BALLARAT TRAMWAYS

1st November, 1949

TRAMWAYS - TAIL LIGHTS

WIRING DIAGRAM
TRAMCAR TAIL LAMP AND
BATTERY CHARGING ARRANGEMENT.

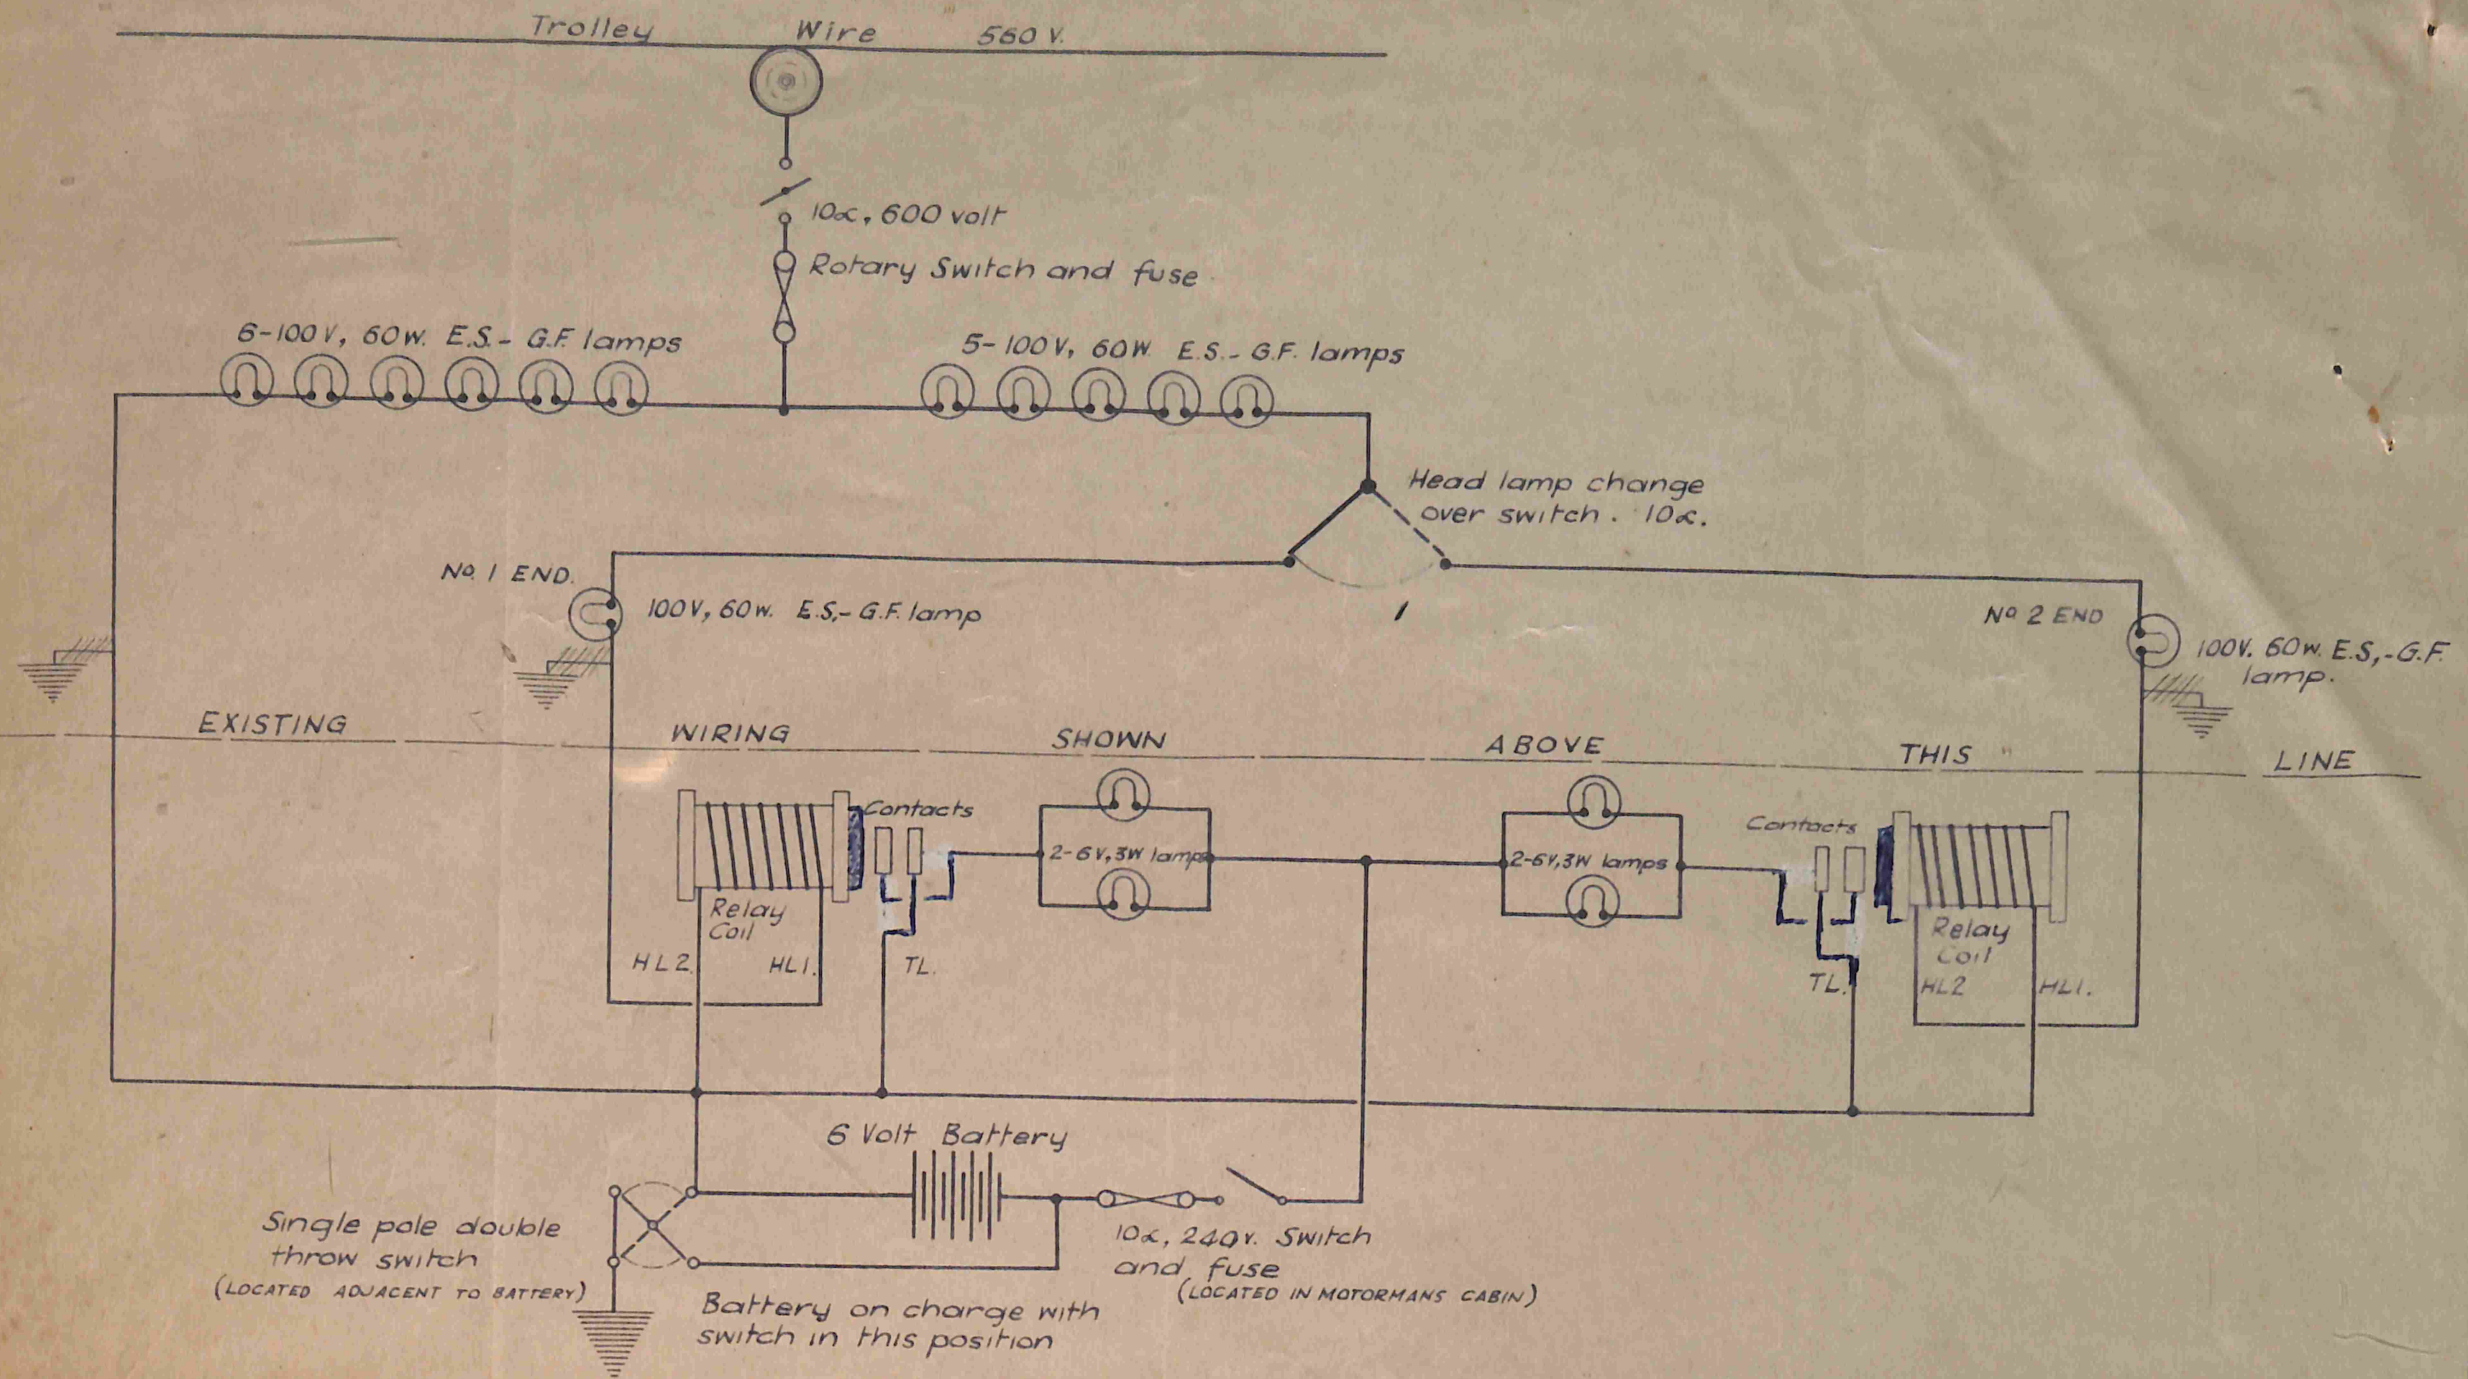
These conditions are contained in the experimental installation detailed in Drawings Nos. 8356-8357, but the manner in which the installation is developed creates some difficulties incurring considerable expense, and also a very definite economic factor in respect to battery charging. The system is, therefore, subject to criticism as follows :-

- (1) The use of packing ring (A) has not been necessary in this branch, and its provision would incur some expense. In explanation, the use of Edison Screw Lamps provides for batten type lamp holders, which are mounted in our headlight castings on adjustable brackets to permit lamp focus to the reflector.

- (2) The type of headlight casting shown in the drawing is only on eleven trams in this branch, and fourteen trams have A.G.E. headlights of shallow type in which the reflector is held by a central bolt to the back of the casting. In these the tail lamp must be separately housed at the back of the casting, and in this regard a special type of elbow has been used.

- (3) The obscure position of the tail lamp and the small lens used require the use of comparatively high wattage lamps to be reasonably effective.
- (4) The obscure position of the tail lamp and the small lens used gives a reduced efficiency other than to the direct rear of the headlamp fitting, the efficiency being almost nil at 90° angle thereto.

- (5) Whilst the tail light is effectively neutralised by the headlight, it is uneconomic that both lamps are required to exert a drain on the battery continuously.

- (6) There is a reduction in red light efficiency in the partial neutralisation effected by motor car headlights impinging on the lens and reflector of the tram headlight, and this neutralisation is greater at the angles where the red light is less effective.

- (7) The provision of special resistance units to provide for battery charging has not been undertaken so far because it is considered that the current consumption entailed renders the system untenable, and also that the disabilities of stability, ventilation and fire safeguards necessary for the dissipation of some 1,750 watts of energy at 560 volts potential, require special consideration. From tests carried out on No. 26 tram, the current taken from the battery rates at 4 amps, and with an average of, say, six hours' operation of tail lamps, would take 24 amp-hours from the battery. The instructions show a resistance to pass 3 amps, and this would require eight hours' operation to maintain the battery. The resistance would be of 185 ohms, and would use 1,750 watts, or approximately 14 kWhrs. per tram per day. With a nominal service of sixteen trams, the daily consumption for battery charging would be approximately 224 kWhrs. On this basis, the estimated consumption would be 1,568 kWhrs. per week, and 81,536 kWhrs. per annum. The added annual cost for power at 0.68d. per kWhr. would be approximately £230. However, on the basis that this load has no diversity and is coincident with peak, the actual cost would be the full demand, plus energy charge, amounting to approximately £325 per annum.

- (A) Use of separate tail lamps for greater efficiency and use of low wattage lamps.
- (B) Reduction of battery drain would permit battery charging through lamp circuits, and eliminate both the use of resistance units and any increase in power consumption.
- (C) Use of relays in headlight circuits to automatically operate the tail lamps.

Experimental tram No. 26 has accordingly been fitted at one end with tail lamps under this scheme, and they also have operated satisfactorily during the three weeks of the tests. It was found that the battery charging rate through the lamp circuits is 1.05 to 1.10 amps. Using twin tail lights of 6-volt 3-watt auto type, the consumption is 1.00 amp. The net result, therefore, of the battery being under charge when the tail lamps are in use is a charge condition of only from 0.05 to 0.10 amp.

The maximum discharge rate with tail lights at both ends would be only 2.00 amps. when power is off or pole removed from the overhead wire. An advantage of the use of twin tail lights would be in the event of a lamp failure, the lamps being wired in parallel. The parts used were obtained from Auto Services, the tail lamps at 6/- each and horn relays at 5/6d. each. The cost of the necessary parts, therefore, would be nominally less than 35/- per tram. No alteration is required to existing fittings, and the wiring is simplified by the reversing of the usual operation of the relay.

Details of the car lighting and the alteration to wiring necessary for this system are shown on the accompanying sketch.
